Final Drainage Report

Security Fire Station No. 4

Project No. 61134

PCD File No. PPR **2029**

0.525
 STR (outfall
 pipe from detention
 Pond)
 100 year

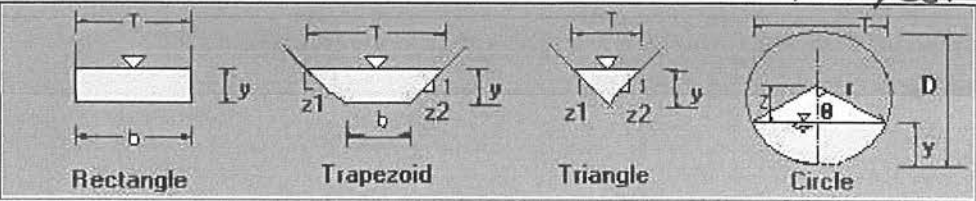
Outflow should be equal or less than the pre-development flow. Please revise.

Exhibit 11: Developed Drainage Conditions (map pocket)

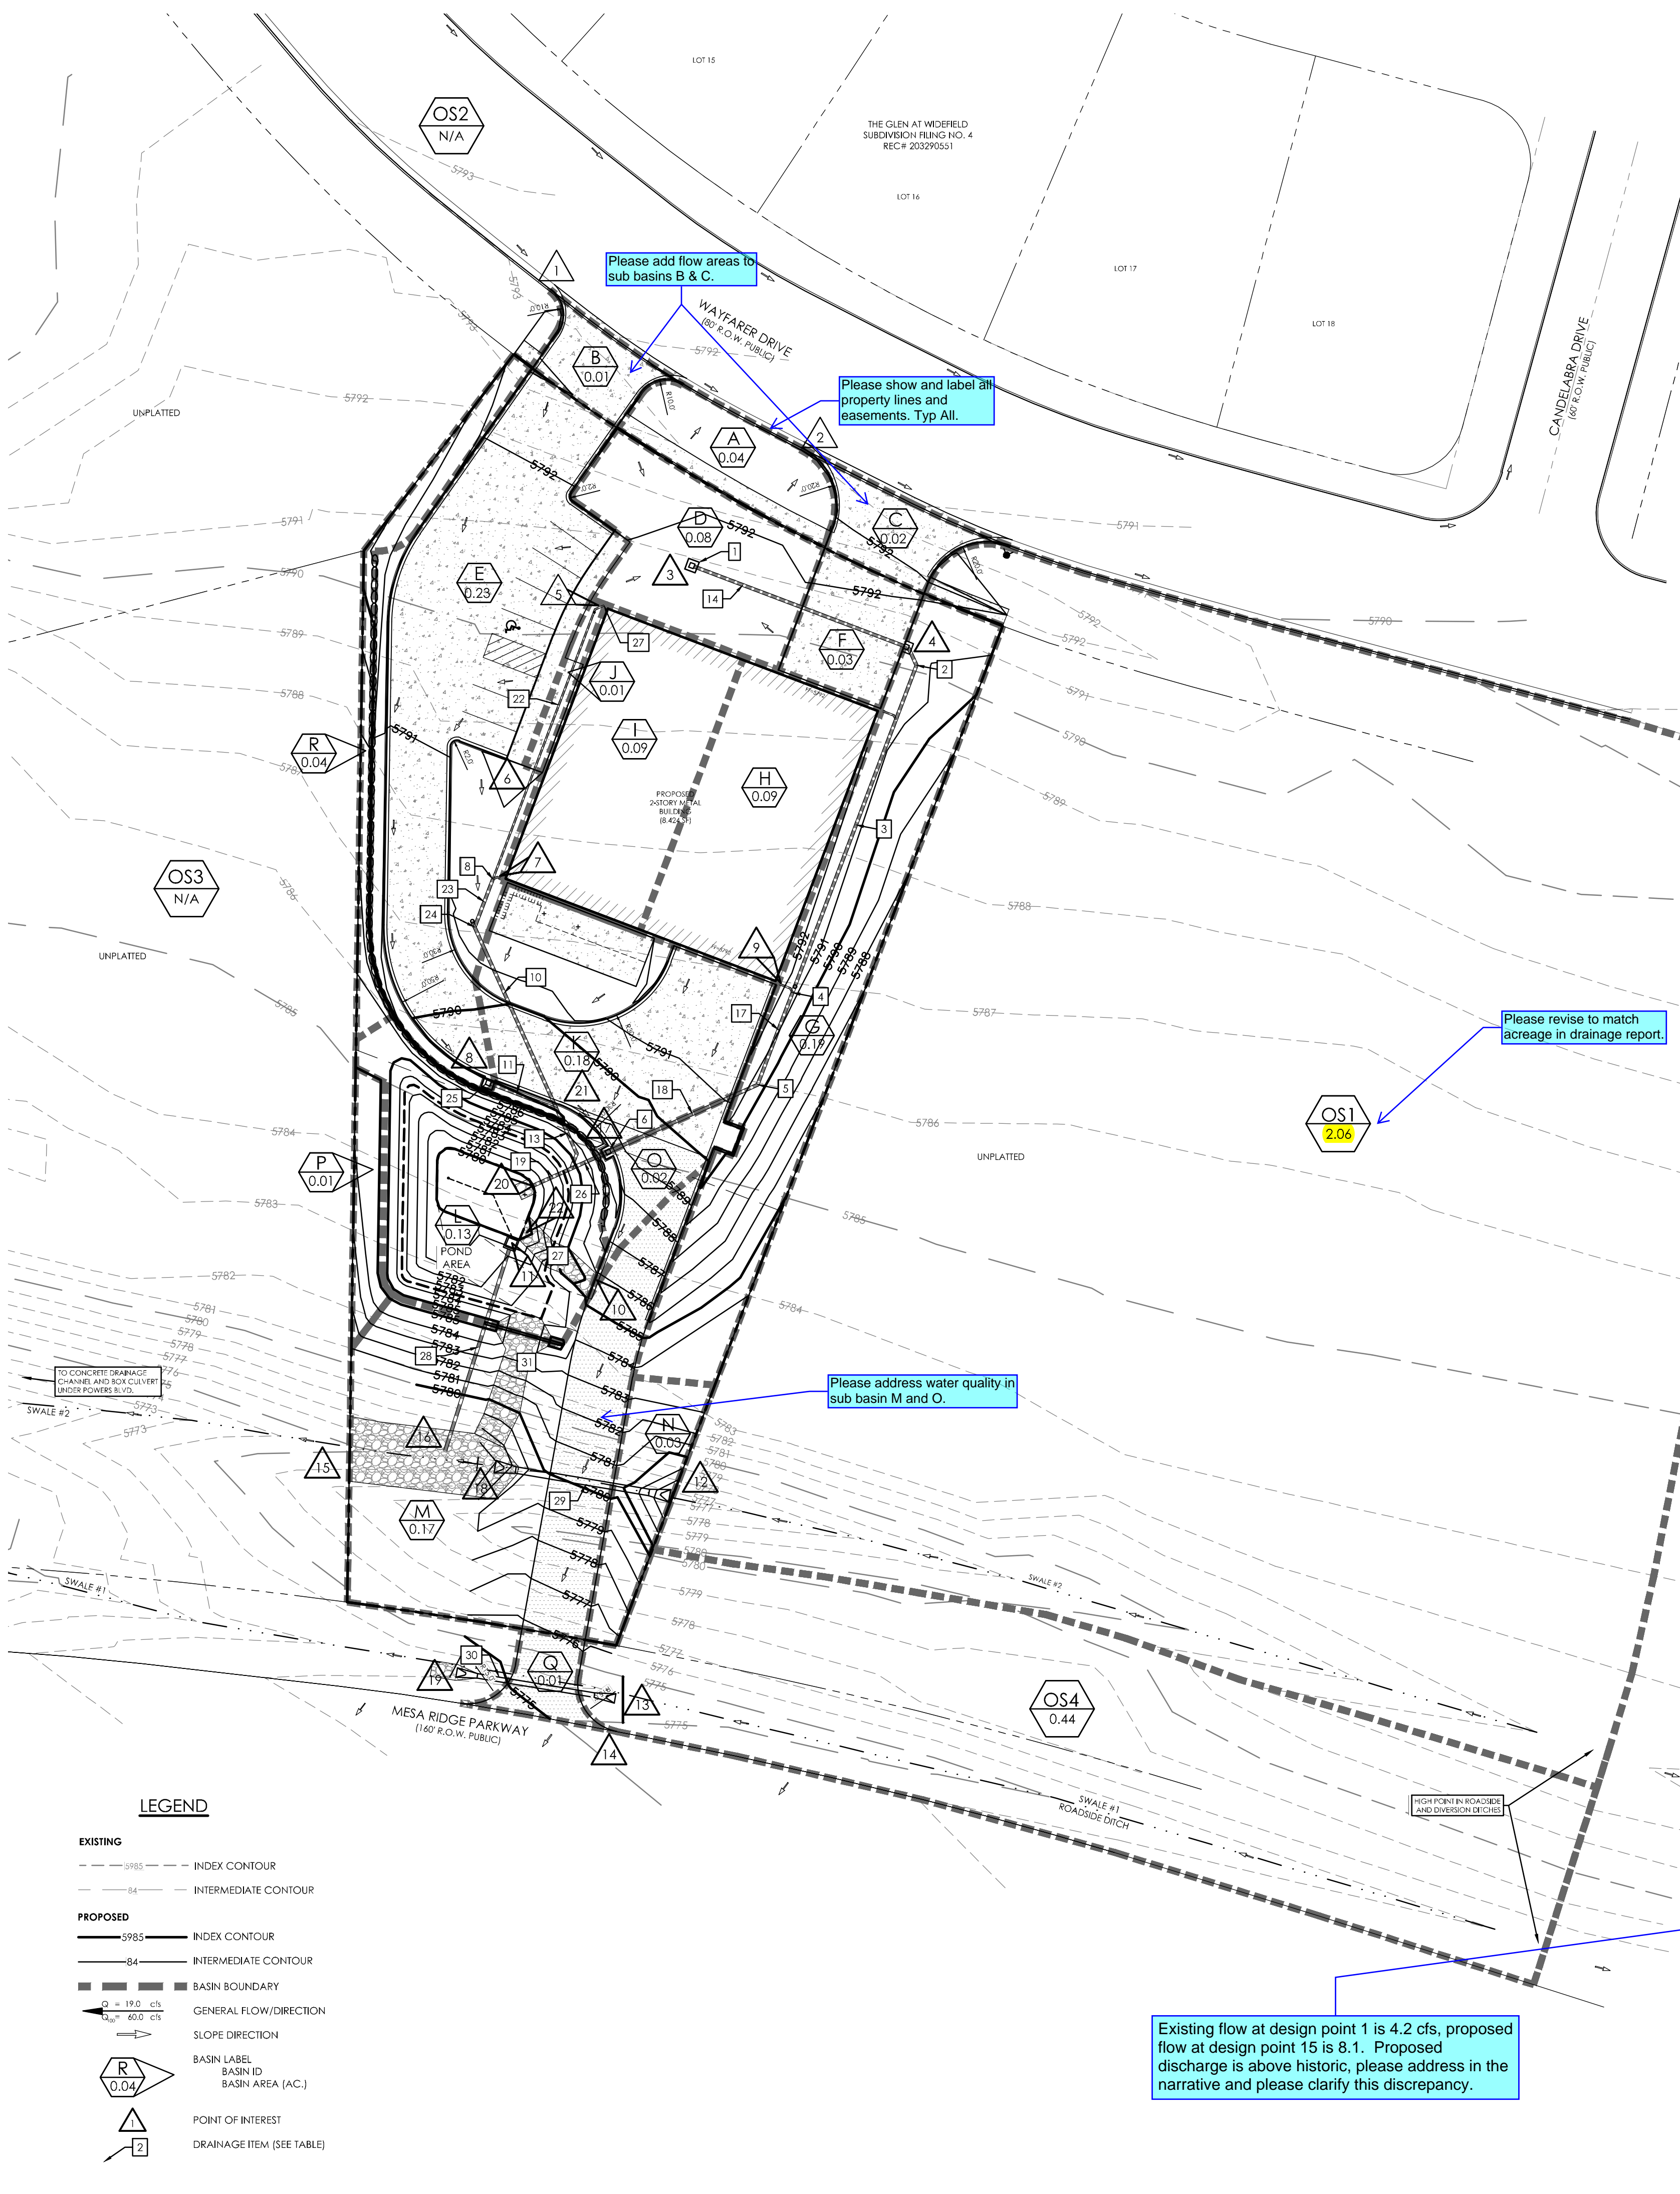
Please add flow areas to sub basins B & C.

Please show and label all property lines and easements. Typ All.

Please revise to match acreage in drainage report.

Existing flow at design point 1 is 4.2 cfs, proposed flow at design point 15 is 8.1. Proposed discharge is above historic, please address in the narrative and please clarify this discrepancy.
